**Livingston County Water and Sewer Authority
Request for Proposals
For Professional Engineering Services
For the
Livingston County Water and Sewer Authority (LCWSA) Regional Water Supply Project
November 13, 2025**

Questions regarding the RFP for Professional Engineering Services:

WATER PUMP STATION FLOOR PLAN

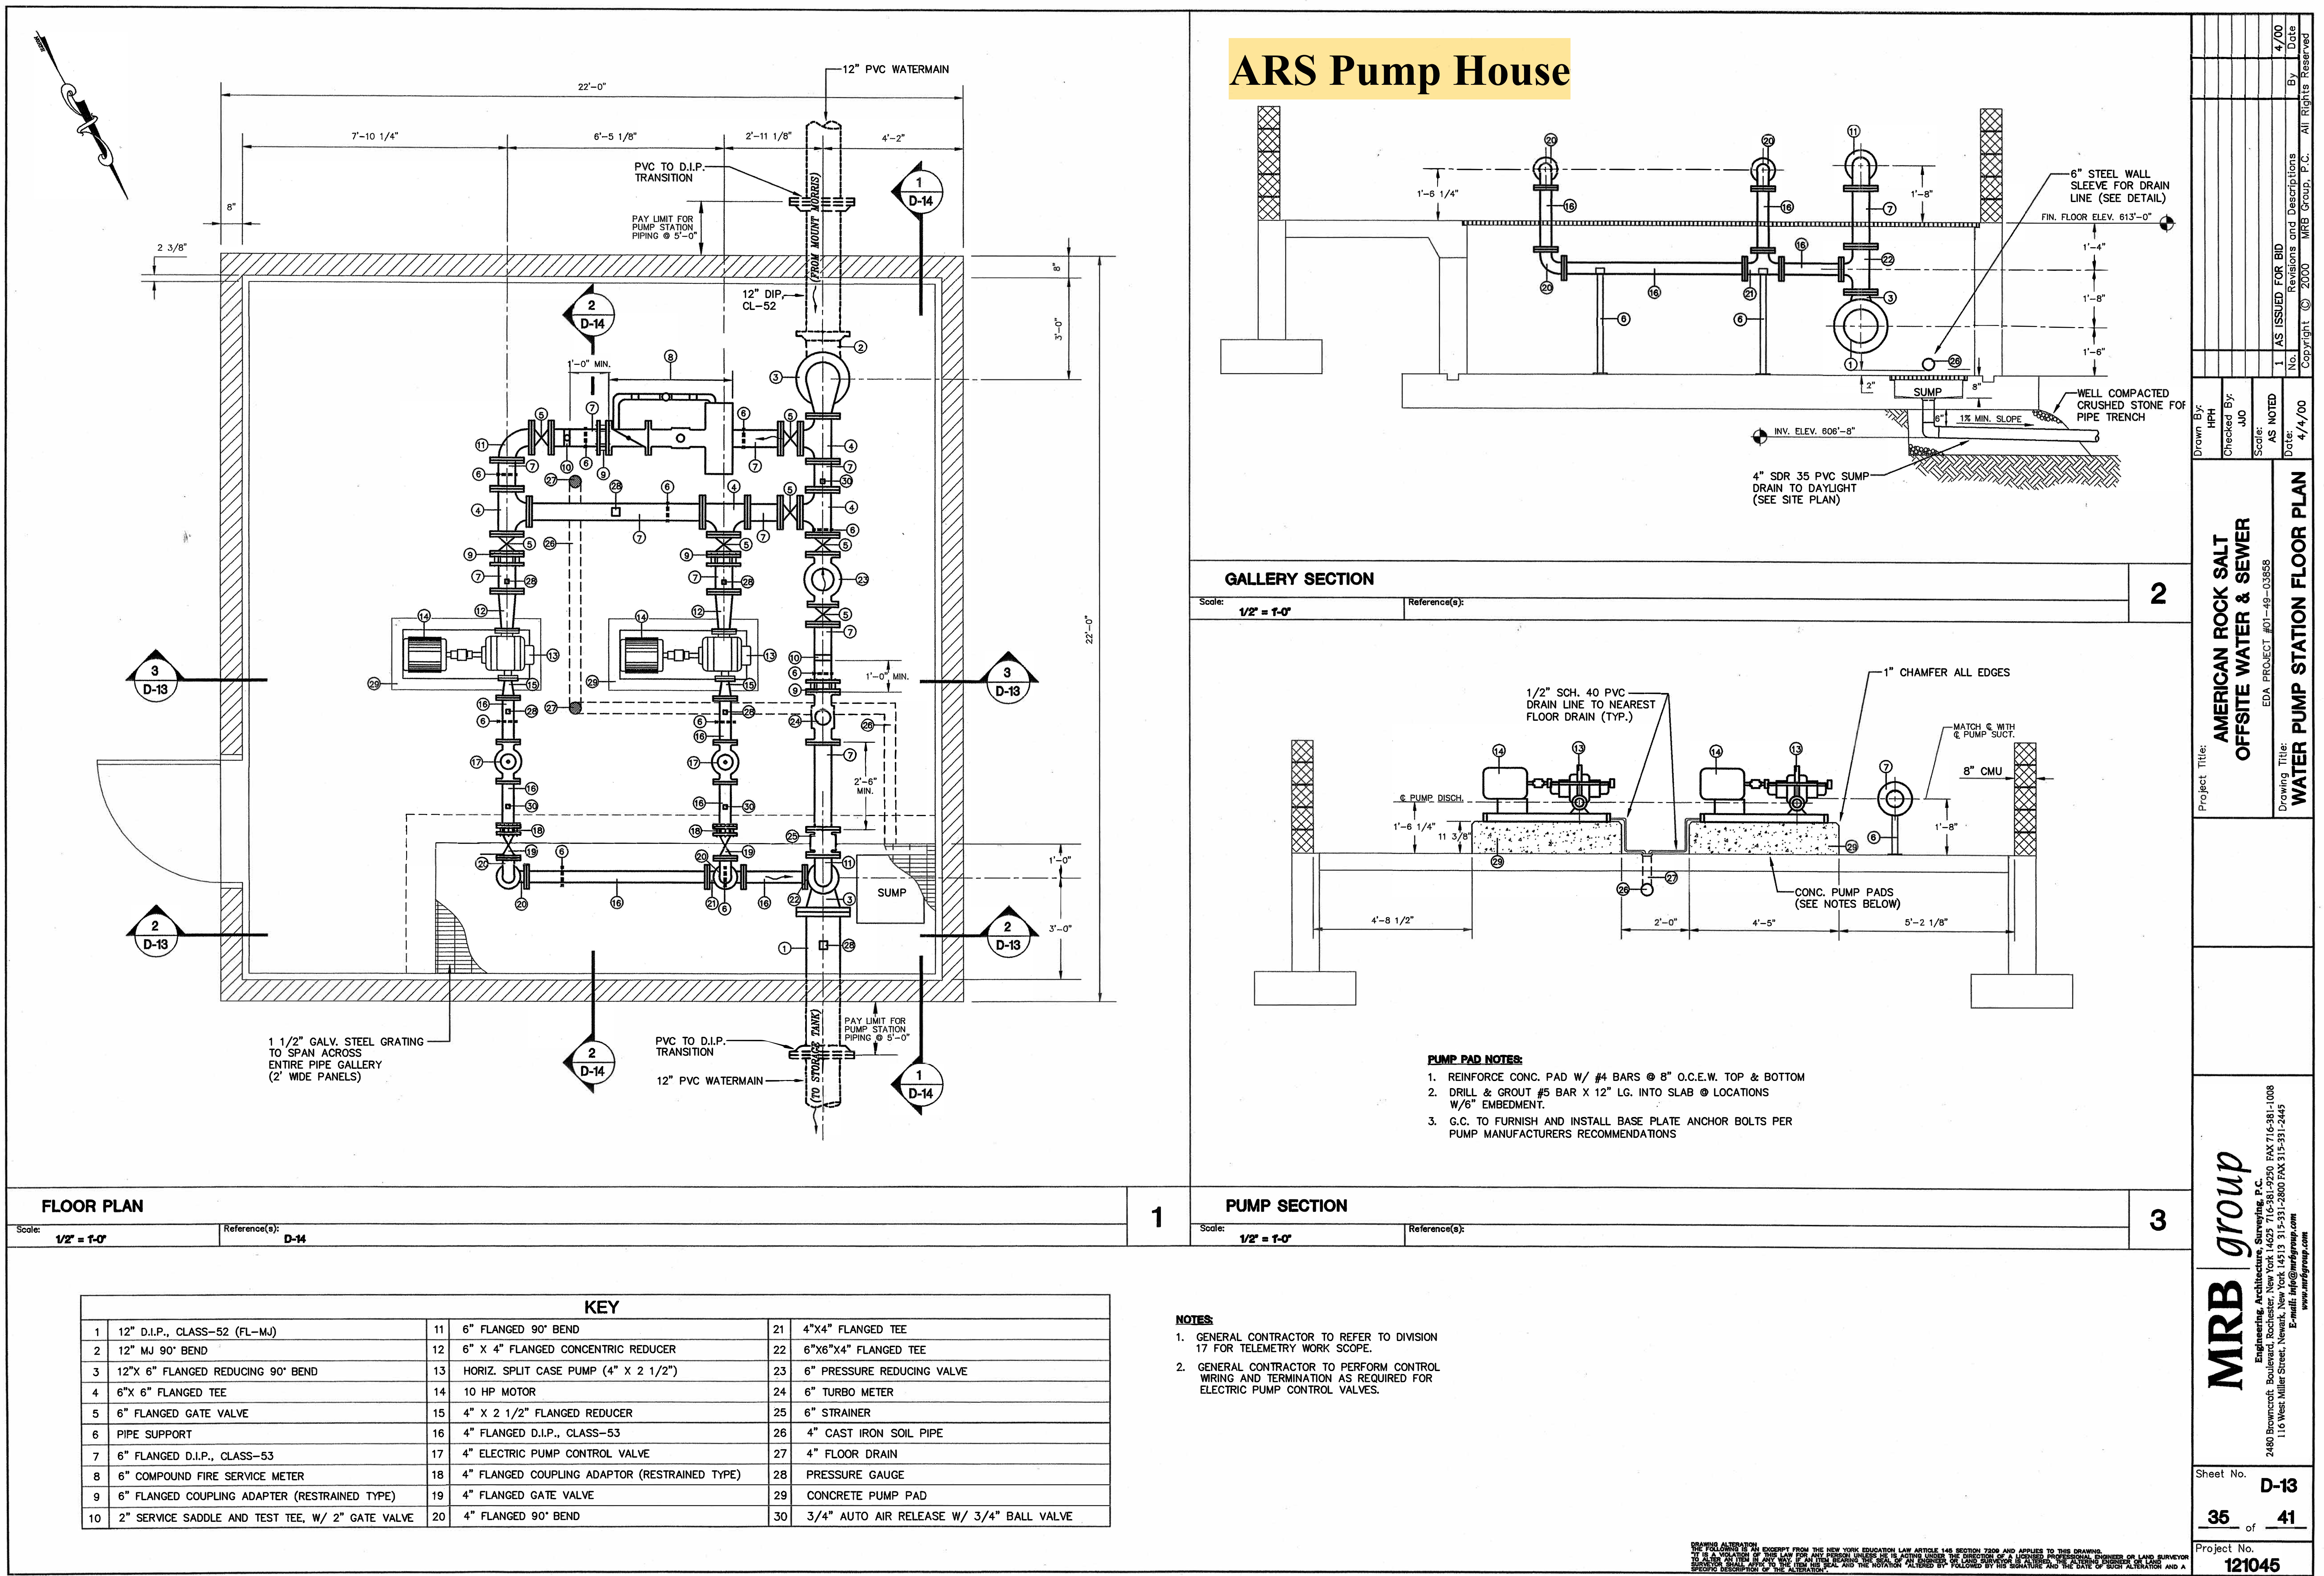
19. For the Mt. Morris master meter interconnection, where will the master meter be installed; inside existing pump house or in an adjacent below grade vault? Can additional information be provided here for this interconnection?

Response: Yes, a master meter will be installed inside an existing pump house. In 2021 the pump house discontinued pumping water from Mt. Morris (west) to the LCWSA ARS water tank as a transmission main was installed connecting the ARS tank to the LCWSA consolidated system (east). The pump house has existing piping and valving that connects the LCWSA system to the Mt. Morris system. Attached please find the floor plans for the ARS pump house.
